# MICROCHIP PIC18F2420/2520/4420/4520

## PIC18F2420/2520/4420/4520 Rev. A1 Silicon Errata Sheet

The PIC18F2420/2520/4420/4520 Rev. A1 parts you have received conform functionally to the Device Data Sheet (DS39631), except for the anomalies described below. Any Data Sheet Clarification issues related to the PIC18F2420/2520/4420/4520 will be reported in a separate Data Sheet errata. Please check the Microchip web site for any existing issues.

**FIGURE 1: SCK PULSE VARIATION USING TIMER2/2**

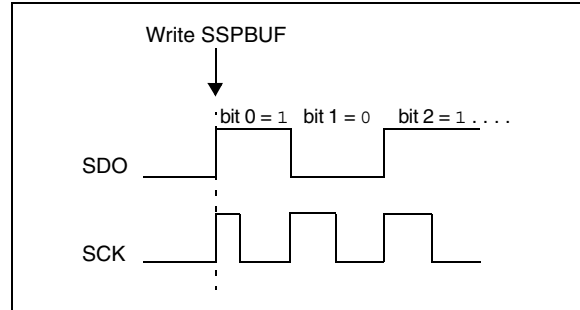
When the SPI is using Timer2/2 as the clock source, a shorter than expected SCK pulse may occur on the first bit of the transmitted/received data (Figure 1).

To avoid producing the short pulse, turn off Timer2 and clear the TMR2 register, load the SSPBUF with the data to transmit and then turn Timer2 back on. Refer to Example 4 for sample code.
